RE: Lot 5 Robartson Road Merredin Development Application - Variation to Battery Energy Storage System DAP Approval 24/02631

Form 2 – Minor Amendments to Approved Battery Energy Storage System

2.3 Changes to approved plans

MERREDIN BIG BATTERY
132/33kV SUBSTATION AND BESS
GENERAL ARRANGEMENT

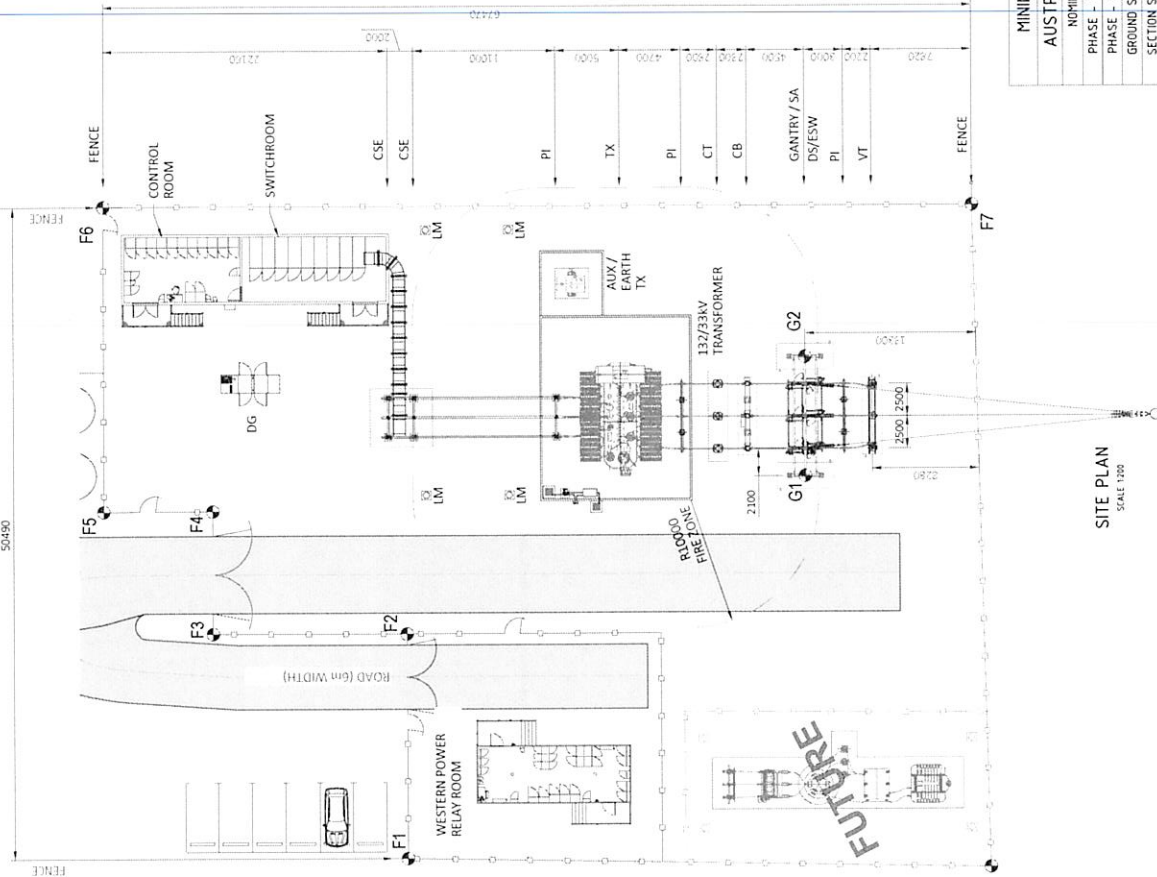
The current RDAP approval shows the battery units aligned in an east-west pattern on the site, design refinement now aligns the battery packs in a north-south pattern over the site. This change will have no significant impact on the site nor its surrounds. The project remains located behind the dam off Robartson Road and adjacent to the existing infrastructure located at the adjacent existing Western Power substation (south of the proposed development). The footprint, size and approximate location of the battery packs, as well as the number within the surveyed site boundary is the same as for the current approved development.

The design refinement has reduced the number of required Ring Main Units to 6 over the site and these will sit between the battery packs as they did in the original approval. There are also 28MV transformers across the site and as per the previous approval these will sit in between the battery packs. This alignment will not have a detrimental effect on the site, nor its surrounds as their location is the same as the current approved development sited in between the battery units on site with the visual impact of the components the same as the previous approval.

The refined design in relation to the HV/MV switchyard has seen a small reduction in size and has moved eastwards closer to the BESS units. The switchyard along with other electrical and ancillary equipment sits within the approved footprint of the previously approved development and consists of the same components just in a slightly altered configuration. This slight change in location has occurred as the control room has moved from in between the battery packs and the switchyard to the north of the switchyard. The change in location will have no detrimental effect on the site nor it's surrounds in terms of the management of the facility nor the visual impact of the facility.
